# Comments 12 and 13

# Comment 12

Dragan Obradovic, Siemens AG

# Offset-from-Master definition

Figure 10-6—ClockMasterSyncOffset state machine

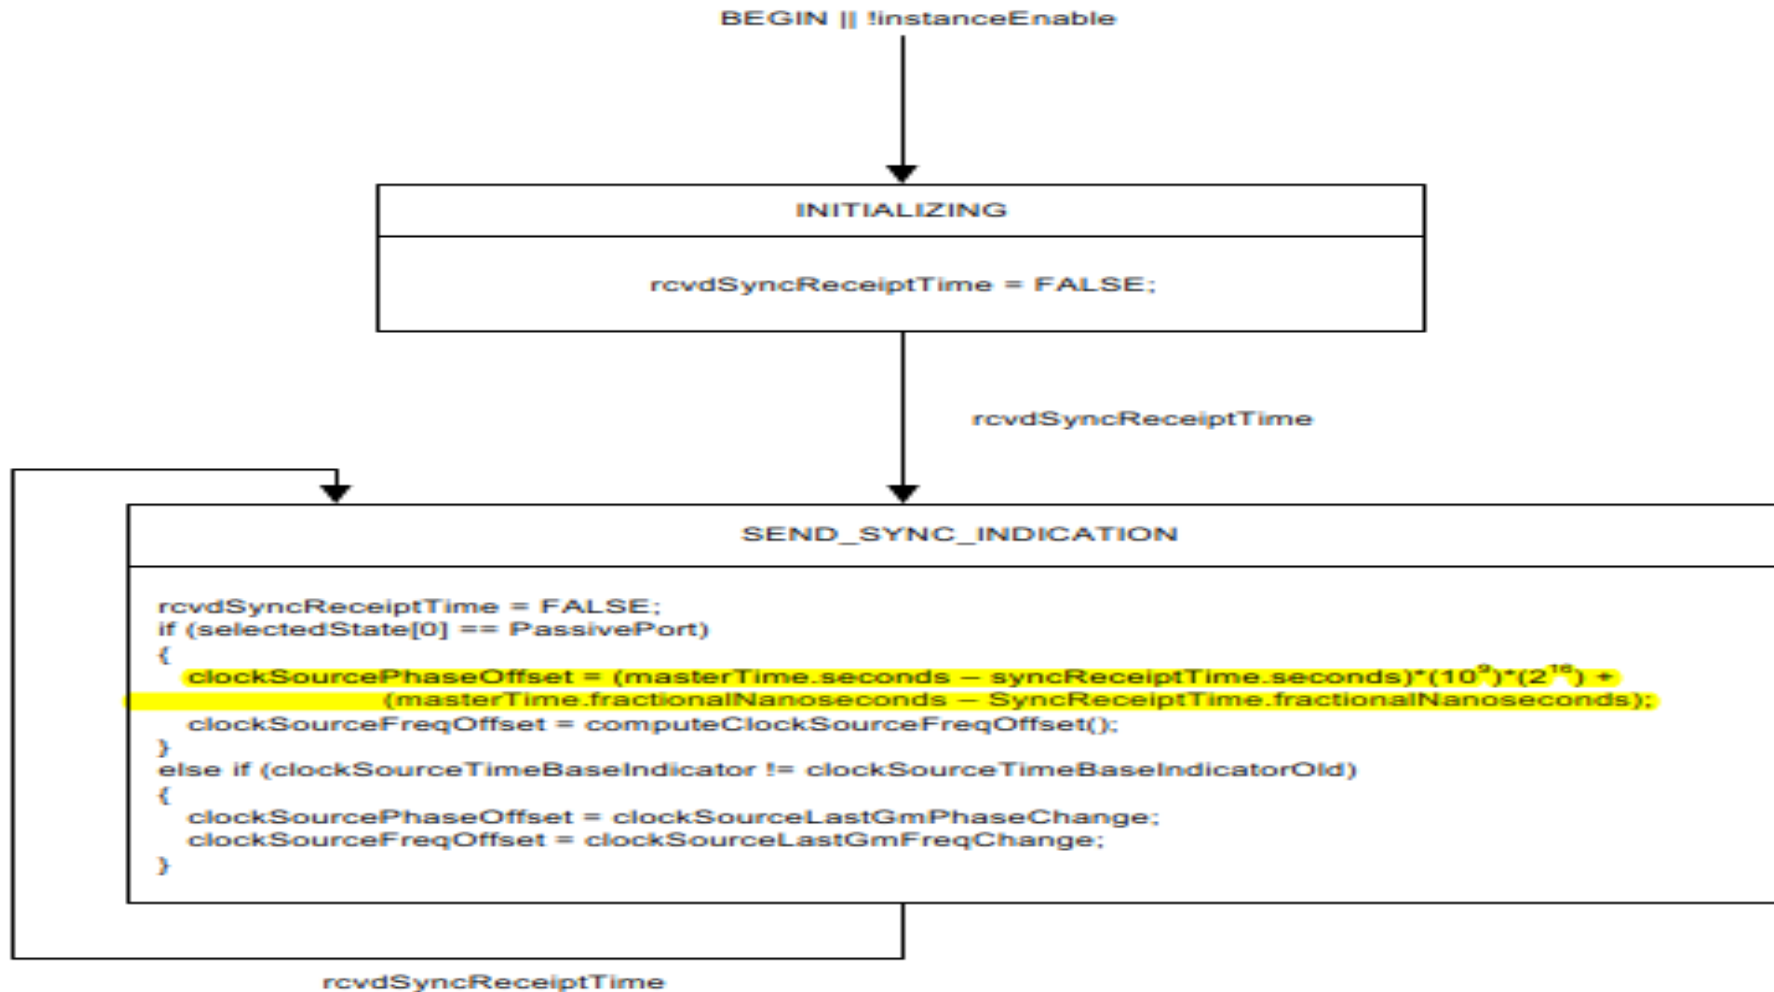
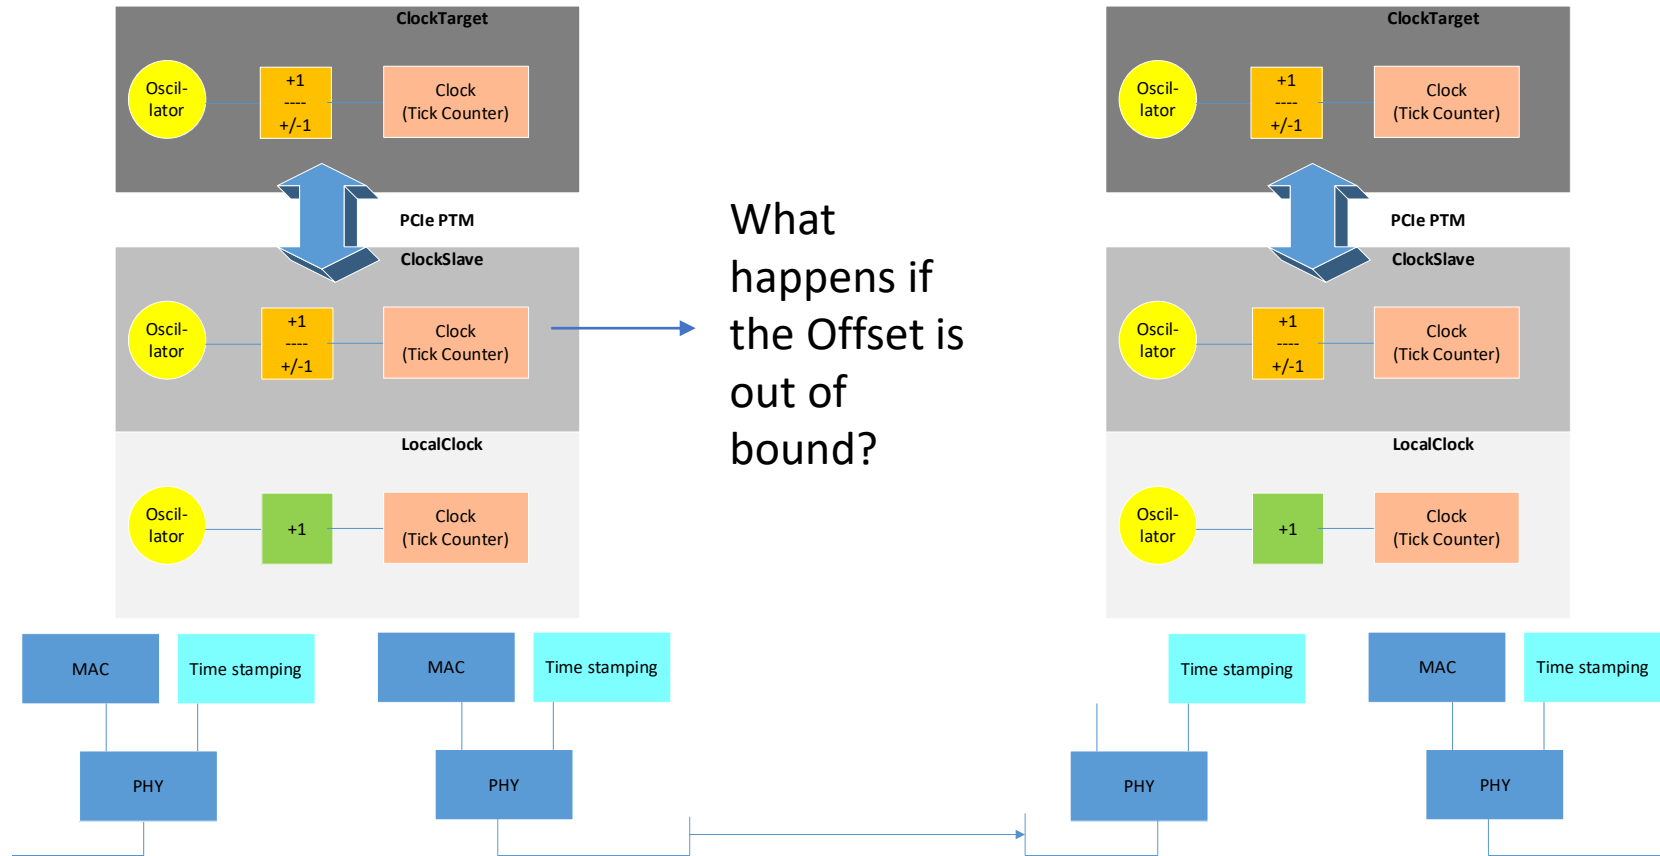
- → [10.2.10](#) `ClockMasterSyncOffset` state machine (shown in [Figure 10-6](#)—`ClockMasterSyncOffset` state machine)
- COMMENT: the above state machine calculates both `clockSourcePhaseOffset` (the conditions not completely clear) and `clockSourceFreqOffset`. Why is this state machine then called “`ClockMasterSyncOffset` state machine”? This is confusing. The conditions (in the if statement) are not easy to understand.
